SNL MWL 07

“Notice of Disapproval: Monitoring Well Plug and Abandonment Plan and Replacement Well Construction Plan, Decommissioning of Groundwater Monitoring Well MWL-BW1, Installation of Replacement Groundwater Monitoring Well MWL-BW2, April 9, 2007”

**Monitoring Well Plug and Abandonment Plan
and
Replacement Well Construction Plan**

**Decommissioning of
Groundwater Monitoring Well MWL-BW1**

Figure 1
Location of MWL-BW1 and Proposed Well MWL-BW2

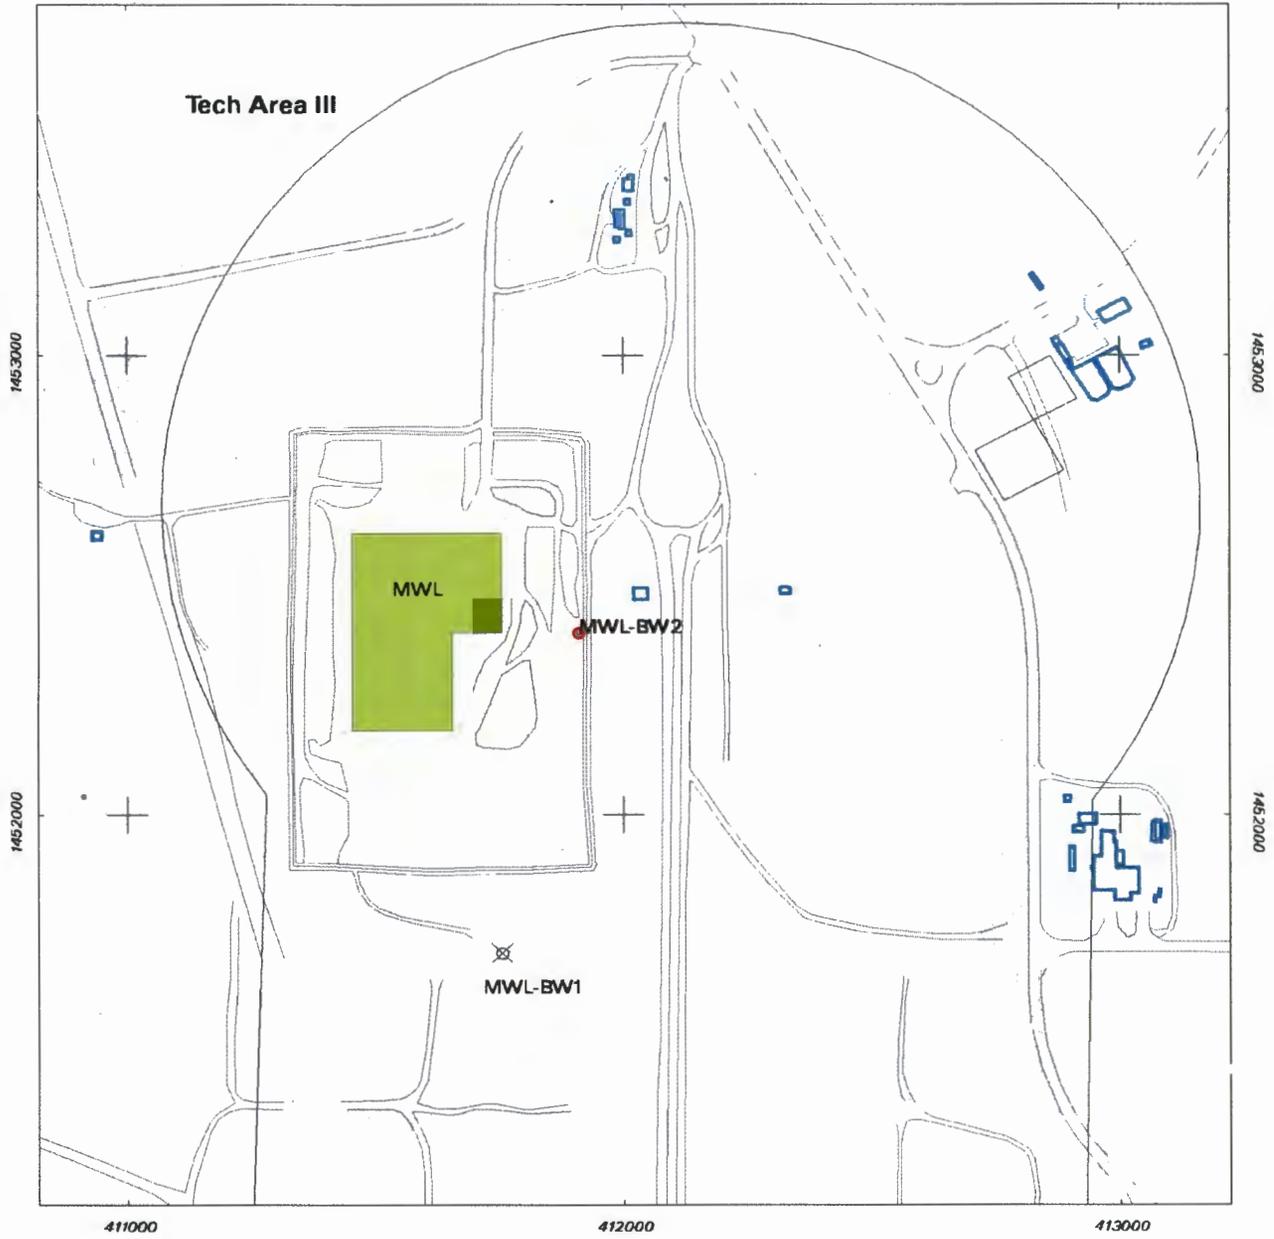
2. Page 5, Section 5.1 – this section states that MWL-BW2 will be installed a minimum of 25 feet away from the existing well (MWL-BW1) location. Later, the text states that MWL-BW2 will be located about 700 feet northeast of MWL-BW1, but that the actual location will be selected with concurrence from NMED. The proposed location for MWL-BW2 as shown on Figure 1 is acceptable to the NMED. A location about 200 feet east of the Mixed Waste Landfill (MWL) should be sufficient. Modify the plan to more precisely indicate the location of proposed well MWL-BW2.

Response: This section of the plan has been clarified and now reads: “MWL-BW2 will be installed at a location approximately 710 ft northeast of MWL-BW1, and approximately 140 ft east of the MWL (Figure 1).” Also, please note that the proposed location for MWL-BW2 has been adjusted slightly to the north from the location shown in the original Figure 1. The new proposed location is now due east of the center of the MWL footprint.
